Interactive comment on “Simplified representation of runoff attenuation features within analysis of the hydrological performance of a natural flood management scheme” by Peter Metcalfe et al.

Peter Metcalfe et al.

Received and published: 9 October 2017

Fig. 1. Eden headwaters to Great Musgrave Bridge (223km²), showing context within Cumbria, UK, rain gauges and gauging stations, and hillslope storage sites identified through JFLOW screening.

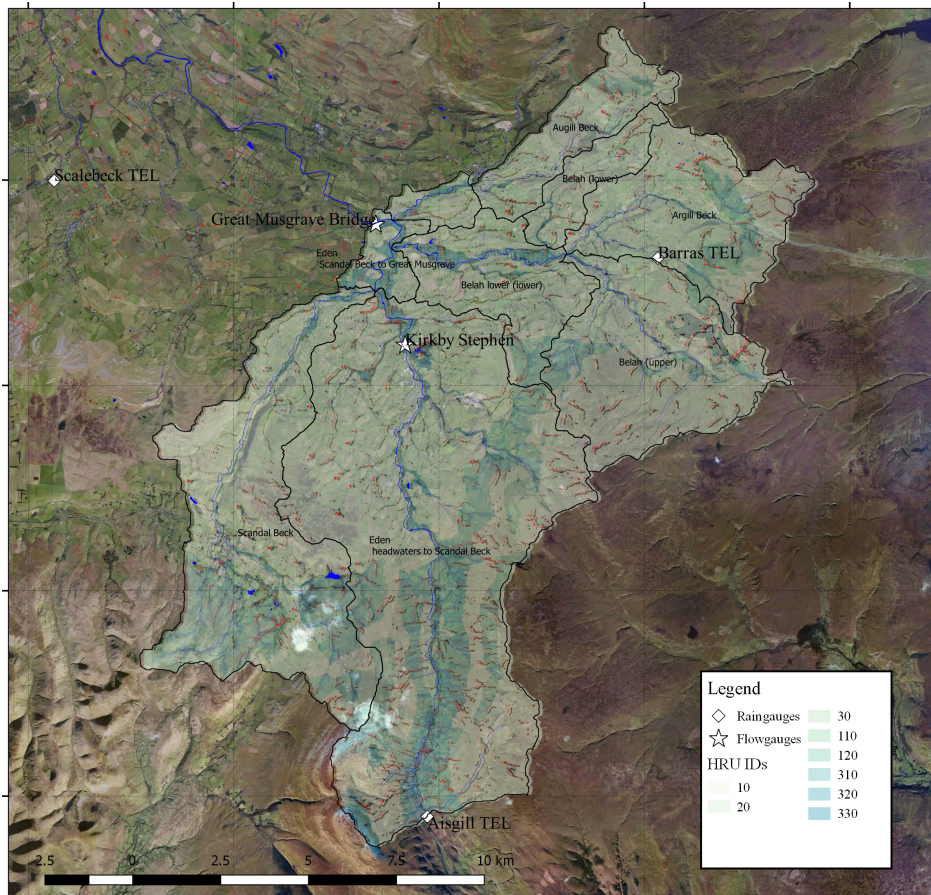
p. 12 I don't understand how 8 HRU units correspond to the JFLOW simulation. Was JFLOW used on 8 separate subregions? Or are the HRUs related to the TOPMODEL simulation? Please, clarify. What is approximate size of the HRUs (are they similar in size)? Can you include HRUs boundaries on Fig. 3?

Comment #22

Fig. 3: I suggest to include the HRUs boundaries. Position of the NFM's would be also interesting, but there are maybe too many of them.

The spatial extent of the "RAF" HRU corresponds to the accumulation areas identified by the JFLOW simulation. Those of the others is determined by the Topographic Wetness Index (TWI, see later comment) as for TOPMODEL. The HRU boundaries can be included on the diagram as requested. The figure will be revised to show HRU boundaries and their areas given. The areas range from 2 to 101 km².

As for Comment 4. It may be that putting both the HRU boundaries and the RAF positions is confusing. Our inclination would be to show only the RAFs. We include a revised figure (Figure 1) with these boundaries included.

Fig. 2. Simulated discharges at Great Musgrave Bridge across the calibration period described in the main text for behavioural realisations alongside rated observed discharges.

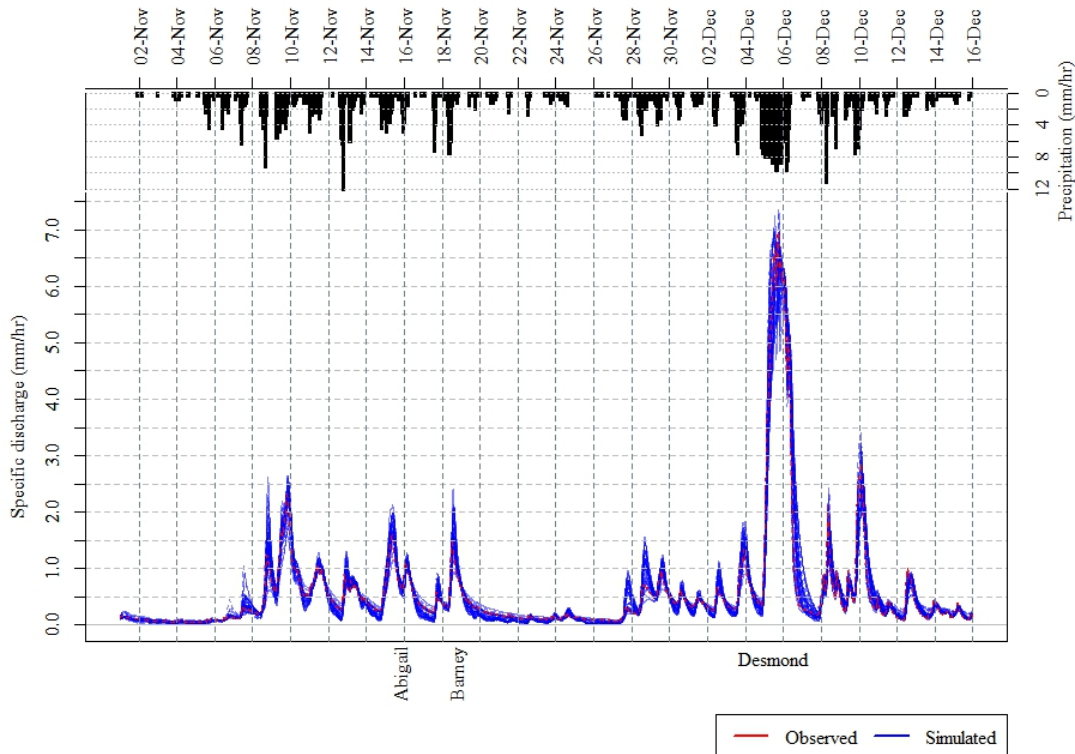
Comment #23

Fig. 4: Why are there more red lines? I would think that there is only one observation

in the single gauge.

The Precipitation bars are too thick. In the given scale the daily precipitation amount on 13th Nov would be app 240 mm.

Thank you for pointing this out. The display of the observed values are indeed in error as the colours had been incorrectly applied; every other time series was being displayed in red. This has been fixed: see Figure 2.

This has been addressed: see Figures 2 and 4.

Fig. 3. GLUE "dotty" plots showing overall weighting (likelihood) scores for each of the 348 behavioural runoff simulations identified against the three model outputs described in the text.

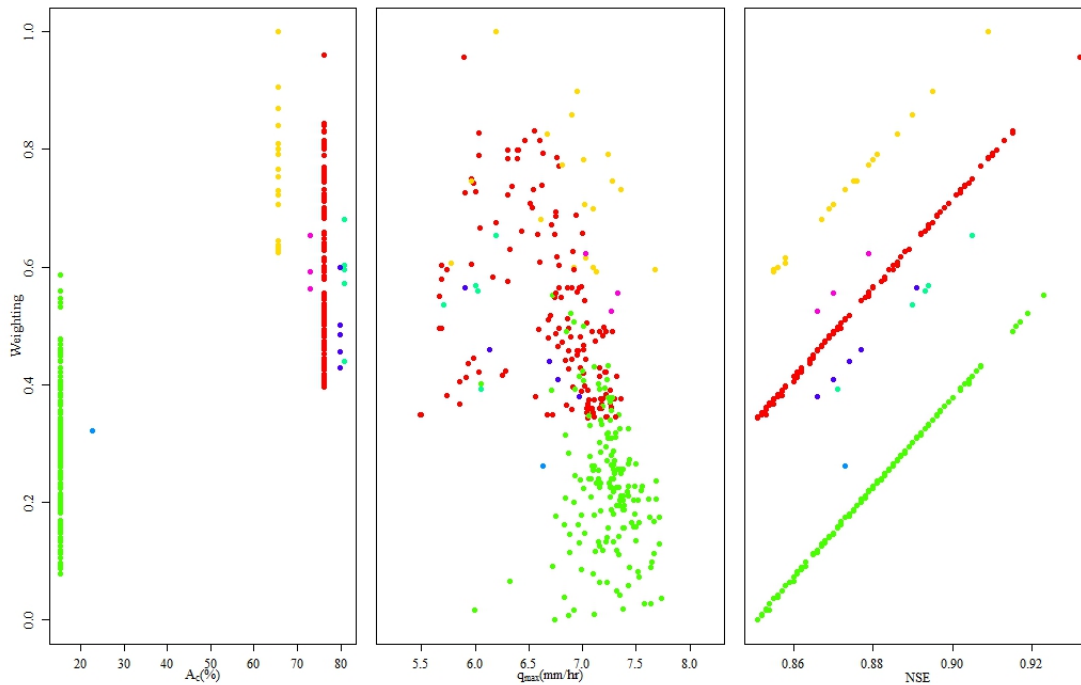
I don't understand to the description of the GLUE results (p.13, l. 13). Why the Ac around 65% gives the best NSE? It does not seem like that on Fig. 5.

Comment #19

p. 13, l. 10: 7 distinct values of Ac are mentioned in the text, only 3 are on Fig. 5.

The yellow lines in have been darkened to make clearer (see Figure 4). Consistent time intervals have been applied to all plots. Colours in the GLUE plots (Figure 3) have been revised to make clearer.

Due to the problem with the colouring (see response to comment 19) the Ac with the best NSE wasn't identified: it is in fact 75%.

Unique colours were not being applied to the unique values. This has been rectified: see Figure 3.

Fig. 4. Surface excess storages across the lumped RAF unit with maximum storage set to 1m, applying each of the three mean residence time scenarios considered.

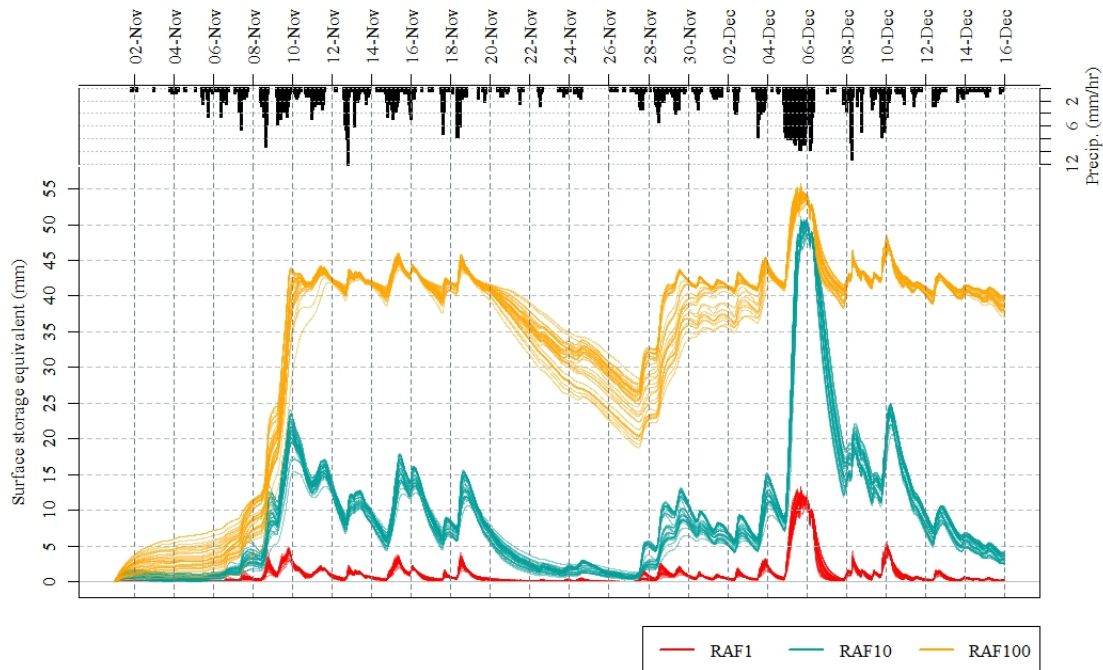
Figures need to be improved. The lines/dots have similar colours (eg. fig 5b - orange, pink). Yellow lines are not visible (fig. 6). Corresponding plots (fig. 4 and 6) have different starting and ending dates, precipitation is not consistent. Etc.

Comment #25

Fig. 5: What are the thin lines with max excess storage around 0.2 m, visible after Desmond storm? Why are they so different from most of the simulation results (for all the RAFs)?

These were the results of simulations that encountered numerical errors and should have not been included in the set identified as behavioural. We will try to pin down what is causing this anomalous behaviour. The corrected figure is included here as Figure 4.
